Mazib Fashions

Mizmizi, Siddhirganj, Narayanganj

9 September 2024

2. Observations

Foundation layout marking the stressed location

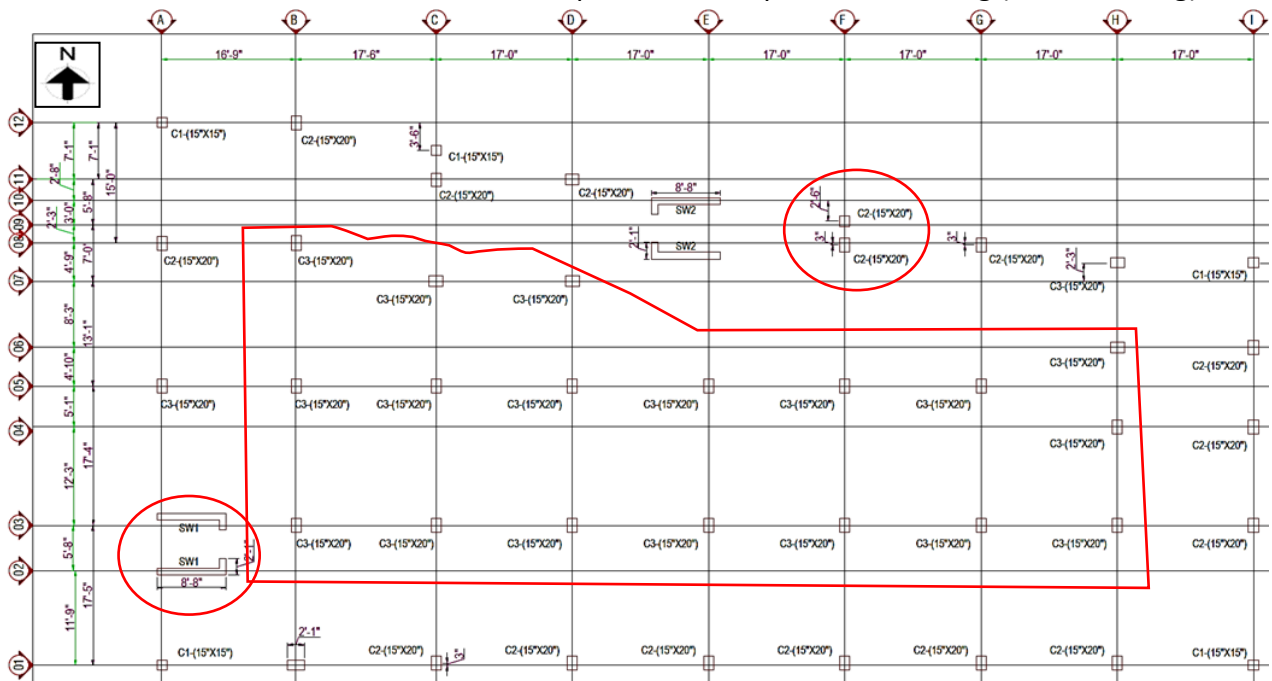
Observation-1: Stress in foundation exceeds normal design limit (Main Building).

Description: cursory calculation indicates that the marked foundation appears to be stressed above normal design limits based on 3 kPa typical floor live load with calculated concrete core strength (29.3 MPa) and re-bar strength (415 MPa). The building engineer is required to carry out Detail Engineering Assessment (DEA) to review the design, loads and column & foundation stress based on in-situ material strength and soil-bearing capacity.

Item No.	Observation	Action Plan	Timeline
1.	Stress in the foundation exceeds the normal design limit (Main Building)	The building engineer is required to carry out Detail Engineering Assessment (DEA) to review the design, loads and column & foundation stress based on in-situ material strength and soil-bearing capacity.	within 6 weeks

C2	SIZE	18"x23"	15"x20"	15"x20"
	TIE	D10-4"-6"-4" C/C	D10-4"-6"-4" C/C	D10-4"-6"-4" C/C

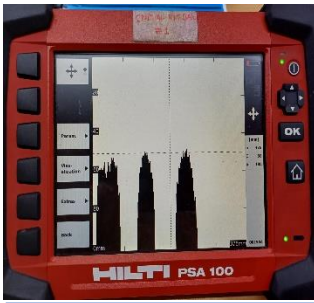
Column C2 size observed 250X375 instead of 375X500 and re-bar profile found by scanning 3/3 (8 no's) instead of 3/5 (12 no's)

Description: During the inspection, discrepancies were observed between the provided drawing and on-site conditions. RC column size & re-bar profile, beam alignment, and shear wall re-bar profile mismatches were observed. Also, no information was available for the roof shed. The building engineer is required to survey the whole structure and update the drawing reflecting actual on-site condition.

C3	SIZE	18"x23"	15"x20"	15"x20"
	TIE	D10-4"-6"-4" C/C	D10-4"-6"-4" C/C	D10-4"-6"-4" C/C

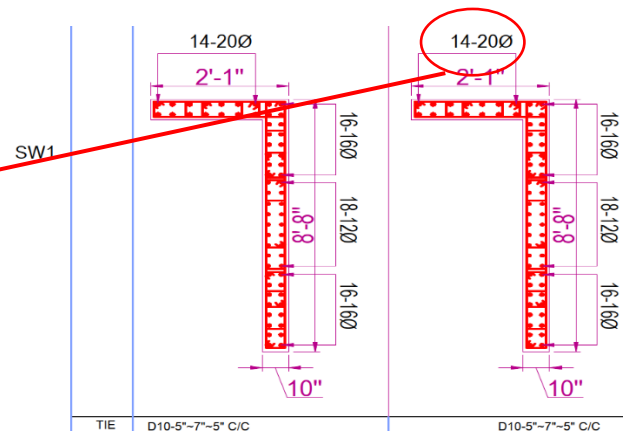
Column C3 (375X500) re-bar profile found by 12Ø20 instead of 8Ø25+4Ø20

Column layout marking the discrepancies

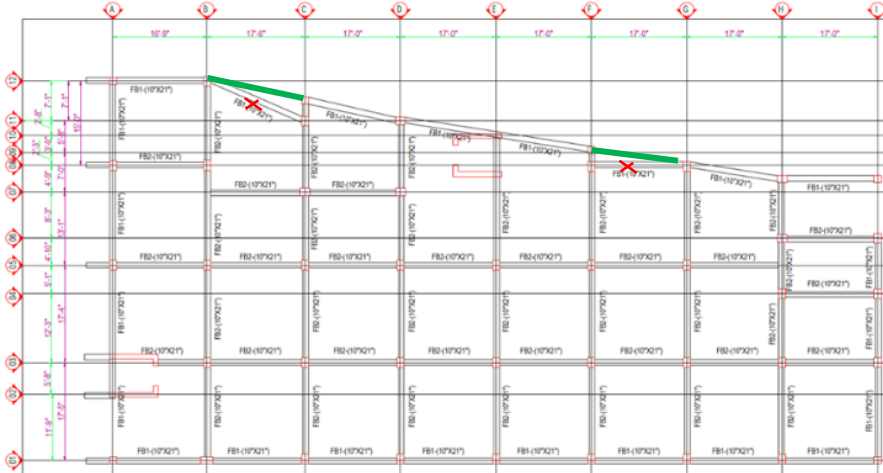
Shear wall re-bar profile found 8Ø20 instead of 14Ø20

Beam alignment mismatching: The marked beams were found in place of green-marked

No drawing was provided for the roof shed

Observation-5: Dampness, exposed re-bar and lack of waterproofing on the roof (Main Building).

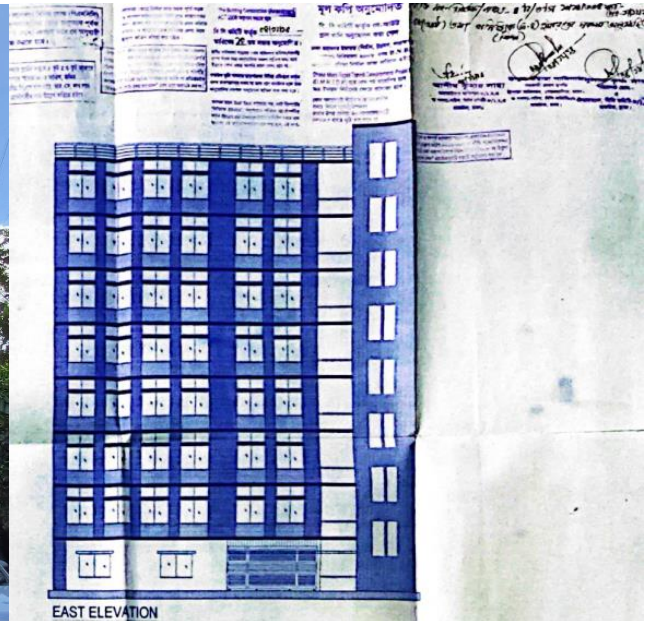
Dampness

Exposed Re-bar

No waterproofing layer on the roof (MCAC on Roof)

Description: During the inspection, dampness was observed in several areas of the building. An exposed re-bar was found on the roof, making it vulnerable to corrosion. Additionally, no waterproofing layer was detected on the roof. The factory is required to address the dampness, apply the anticorrosive coating to the exposed re-bar, and construct a waterproofing layer on the roof.

5.	Core layout missing (Main Building)	The building engineer is required to prepare the core layout	within 6 weeks
6.	Dampness, exposed re-bar and lack of waterproofing on the roof (Main Building)	The factory is required to address the dampness, apply the anticorrosive coating to the exposed re-bar, and construct a waterproofing layer on the roof.	within 6 months

Observation-6: Possible vertical extension (Main Building).

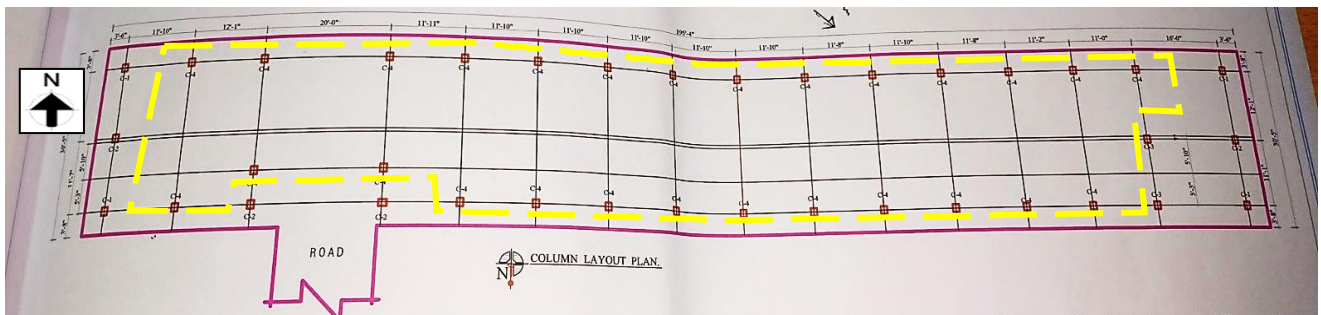
Description: The factory has taken RAJUK (Local Authority) approval for the 8-storied (G+7) Main Building dated 4 December 2014. Also, projected reinforcement is left at the current roof which indicates possible future vertical extension. The building engineer is required to prepare a Detailed Engineering Assessment (DEA) report before conducting any vertical extension.

7.	Possible vertical extension (Main Building)	The building engineer is required to prepare a Detailed Engineering Assessment (DEA) report prior to conducting any vertical extension.	within 6 months

Column layout- yellow marking of all C4 columns' size & re-bar mismatch

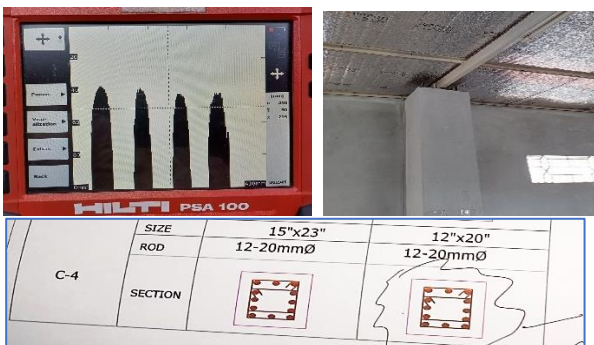
Column C4 size observed 300X375 instead of 300X500 and re-bar profile found by scanning 3/4 (10 no's) instead of 3/5 (12 no's)

No drawing was provided for steel part and marked locations

Description: During the inspection, discrepancies were observed between the provided drawing and on-site conditions. RC column size and re-bar profile mismatches were observed. Also, no information was available for the steel part and above marked areas of the structure. The building engineer is required to survey the whole structure and update the drawing reflecting actual on-site condition.

Building Plan

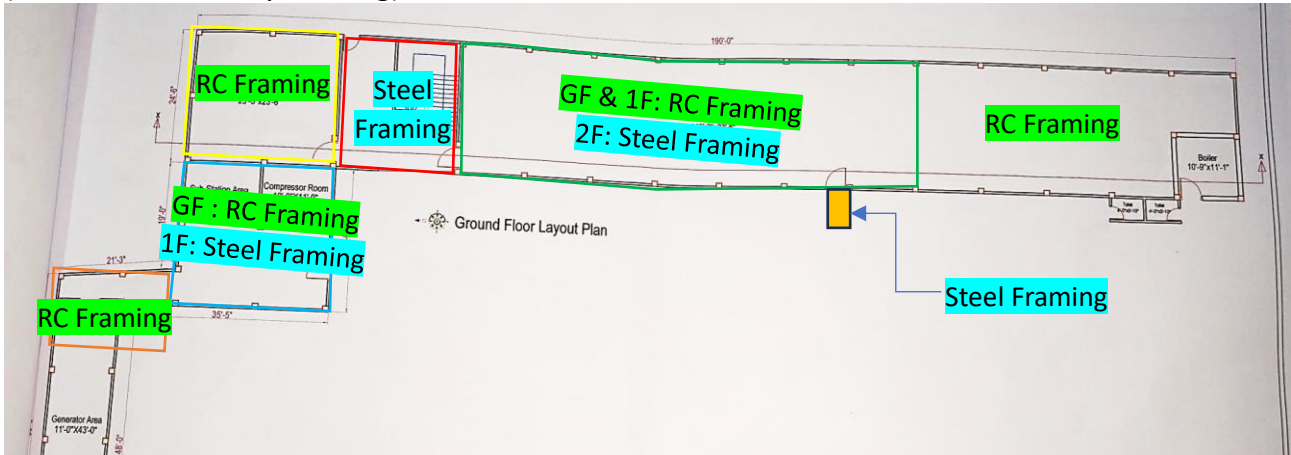
Observation-8: Different structural framing systems and lack of engineering assessment documents (Warehouse & Utility Building).

Steel Roof Shed (G+2 RC including steel roof shed)

RC Beam-Column framing

Description: The building consists of both RC & steel framing systems where the shape of both framing is horizontally irregular. The irregular shape induces torsion in the structure. Also, the structural integrity of the structure is questionable. The building engineer is required to check the framing system & structural integrity of the structure and prepare an EA report addressing the above-mentioned issues.

9.	Different structural framing systems and lack of engineering assessment documents (Warehouse & Utility Building)	The building engineer is required to check the framing system & structural integrity of the structure and prepare an EA report addressing the above-mentioned issues.	within 6 weeks
